49 CFR Part 571

[DOT Docket No. NHTSA–99–5157]

Federal Motor Vehicle Safety Standards; Bus Emergency Exits and Window Retention and Release

ACTION: Final rule.

Figure 6A. Side Emergency Exit – No Wheelchair Anchorages within the shaded region

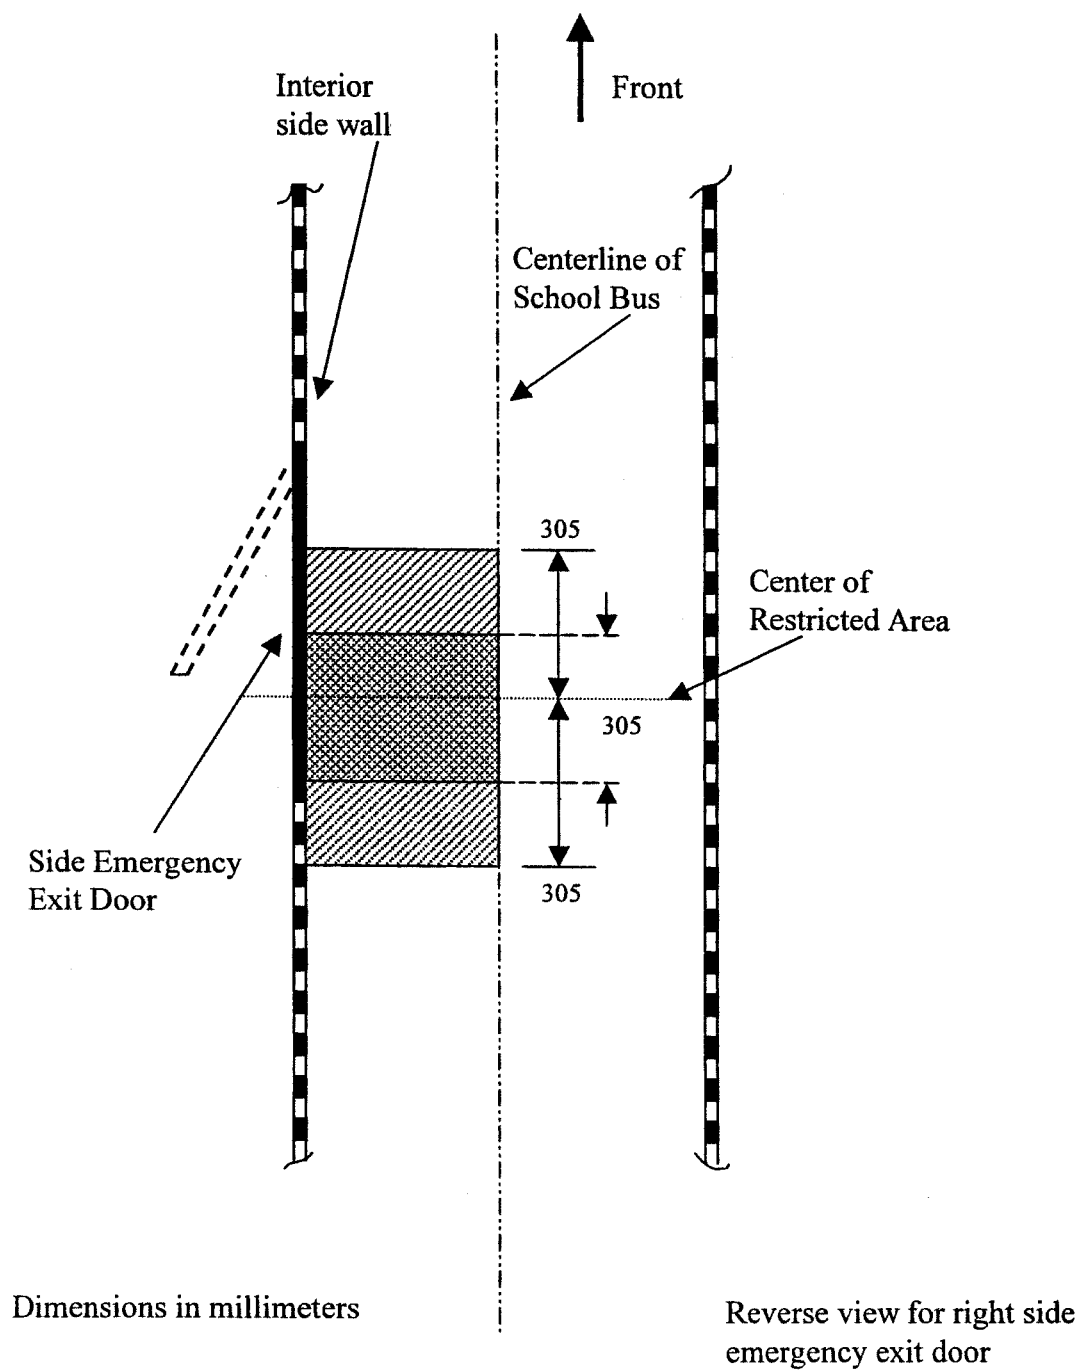
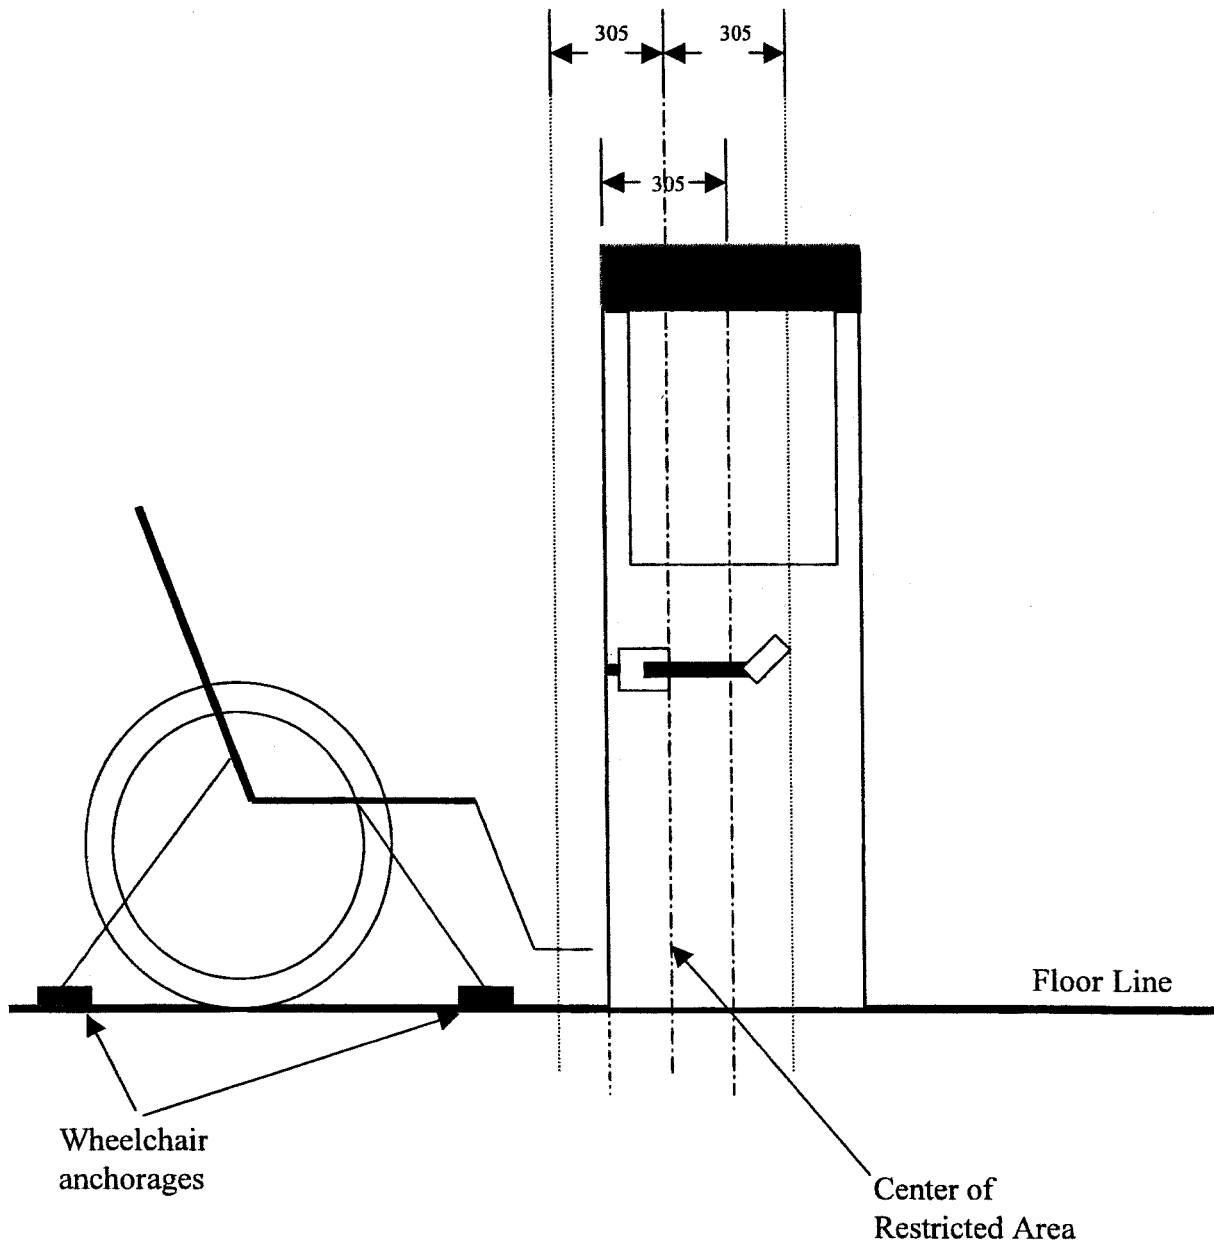
NHTSA concurs with the public comments that 635 mm (25 inches) as measured from the center of the required side emergency exit door aisle is too design restrictive because it would unduly restrict the capacity of

the school bus. NHTSA believes that 305 mm (12 inches) clearance on either side of the center of the aisle would provide adequate clearance to ensure that wheelchair anchors are not placed so that a wheelchair would block access to side emergency exit doors. The 305 mm (12 inches) clearance is adopted because NHTSA believes that the approximately twelve inches of space (in addition to the already specified 305 mm (12 inches) clearance in S5.4.2.1(a)(2)(i)) is needed to accommodate items such as extended foot rests or other parts that extend from the wheelchair.

(a) In the case of side emergency exit doors, any portion of the wheelchair securement anchorage is within the space bounded by the interior side wall and emergency exit door opening, transverse vertical planes 305 mm (12 inches) forward and rearward of the center of any side emergency exit door restricted area, and a longitudinal vertical plane through the longitudinal centerline of the school bus, as shown in Figure 6A and Figure 6B.

Figure 6C. Rear Door Emergency Exit - No Wheelchair Anchorages within the shaded region

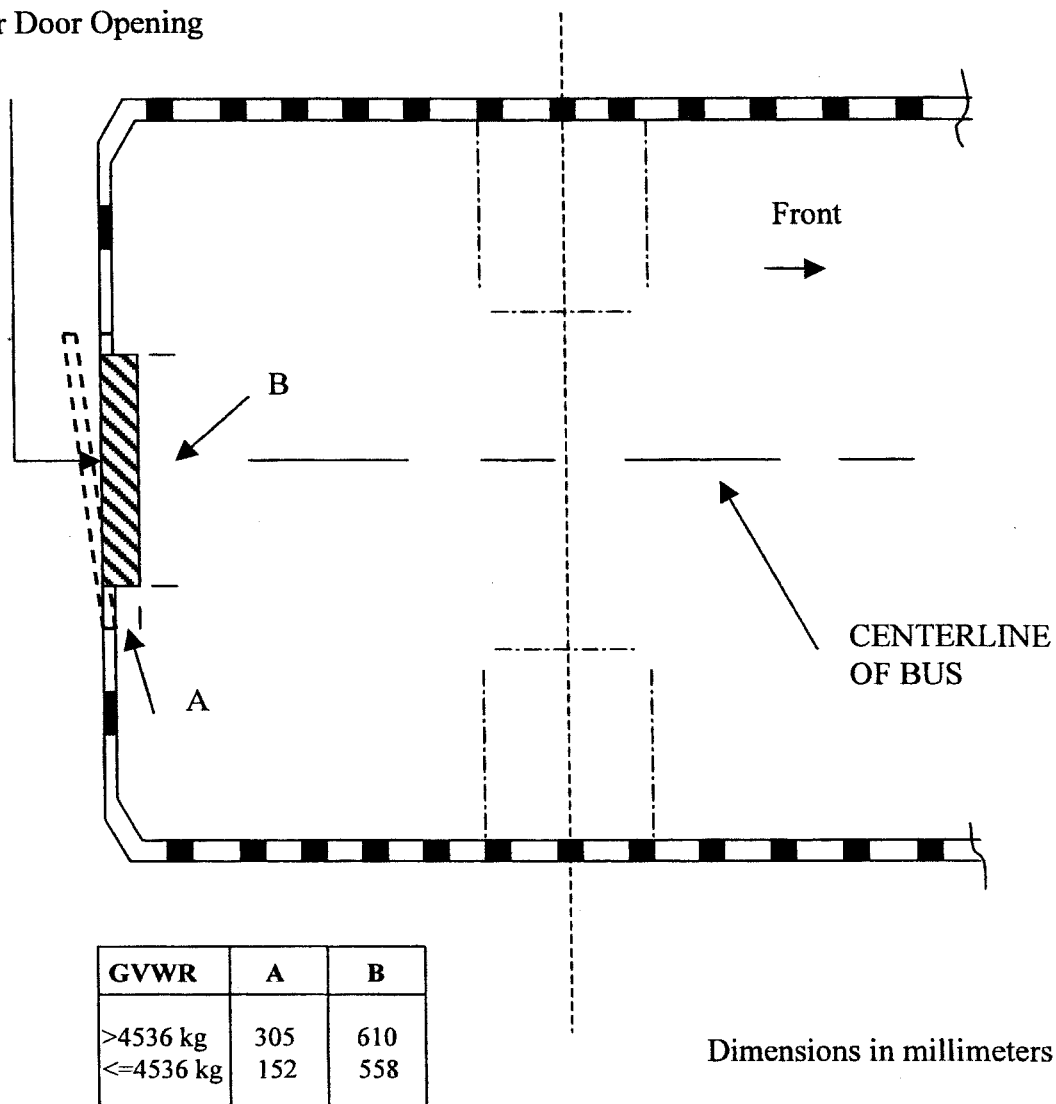
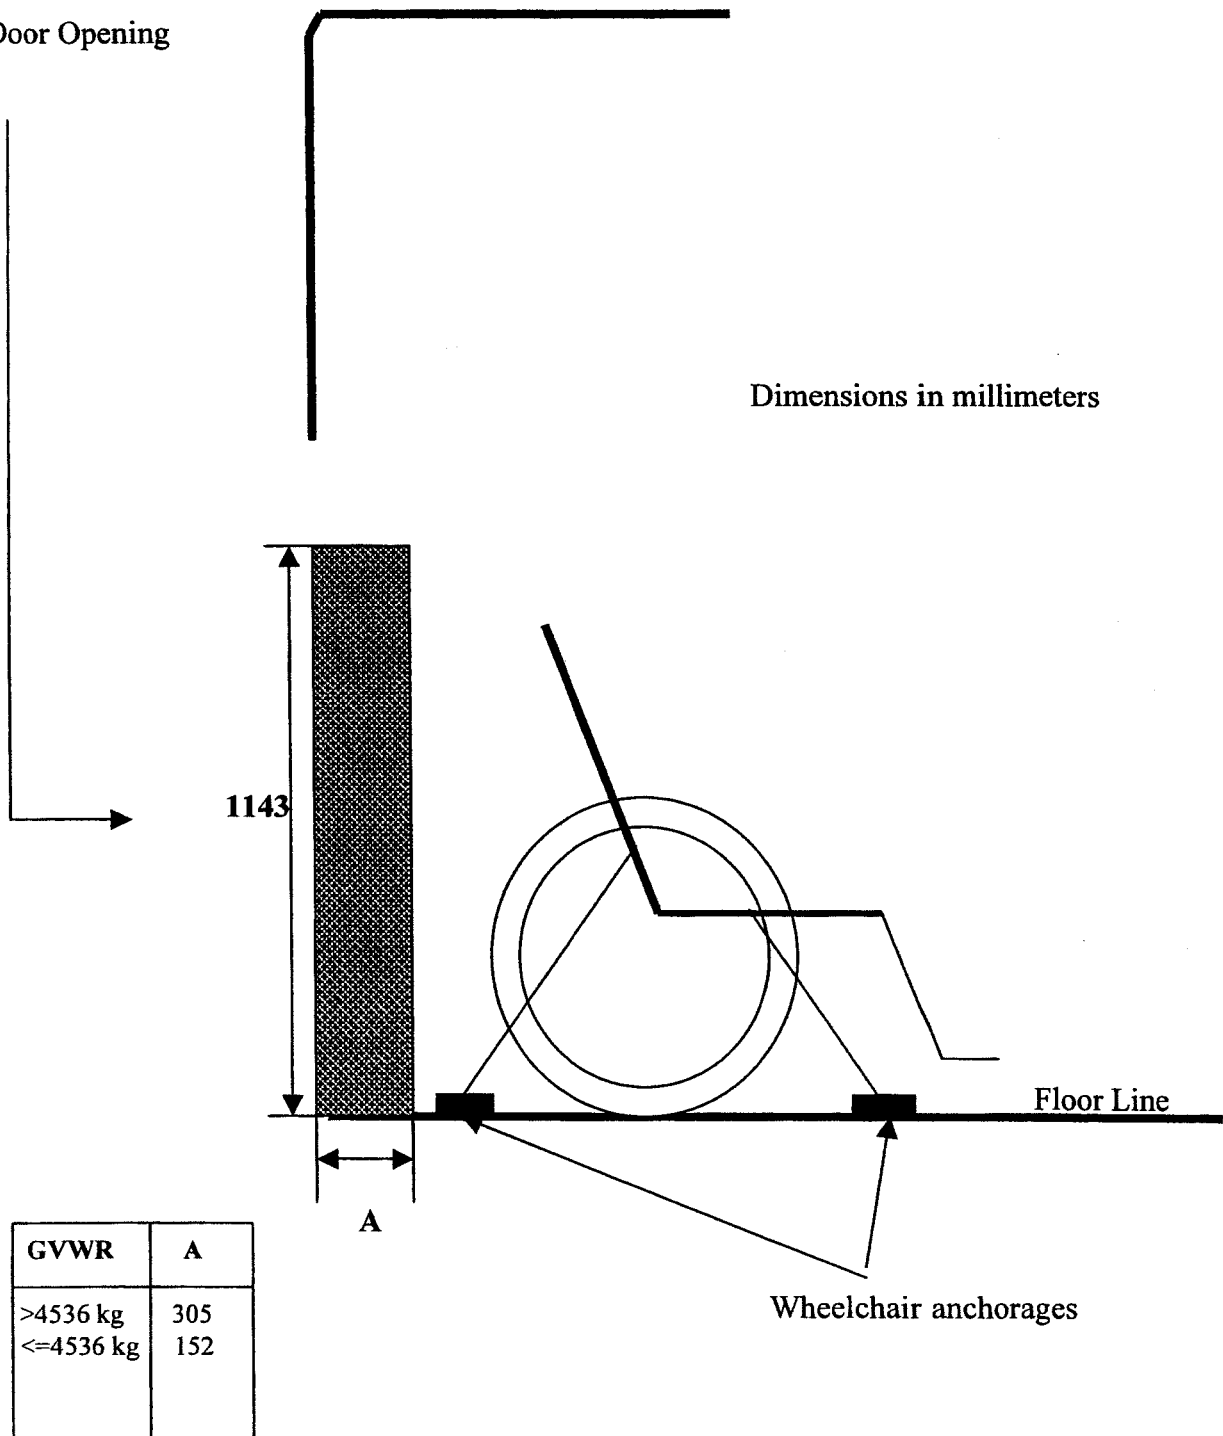
The restricted space adopted for over 4,536 kg GVWR school buses is the same as NPRM’s proposed size of the parallelepiped used to measure the space where wheelchair securement anchorages would not be placed, that was proposed for all school buses. In the final rule, for school buses with a

NHTSA adopted the separate definitions of restricted space for different sized school buses to minimize the number of wheelchair and nonwheelchair seating positions that would be lost as a result of this final rule.

(b) In the case of rear emergency exit doors in school buses with a gross vehicle weight rating greater than 4,536 kg (10,000 lb), any portion of the wheelchair securement anchorage is within the space bounded by longitudinal vertical planes tangent to the left and right sides of the door opening, a transverse vertical plane 305 mm (12 inches) forward of the bottom edge of the door opening, and a horizontal plane 1,145 mm (45 inches) above the floor of the bus, as shown in Figure 6C and Figure 6D.

planes tangent to the left and right sides of the door opening, a transverse vertical plane 150 mm (6 inches) forward of the bottom edge of the door opening, and a horizontal plane 1,145 mm (45 inches) above the floor of the bus, as shown in Figure 6C and Figure 6D.
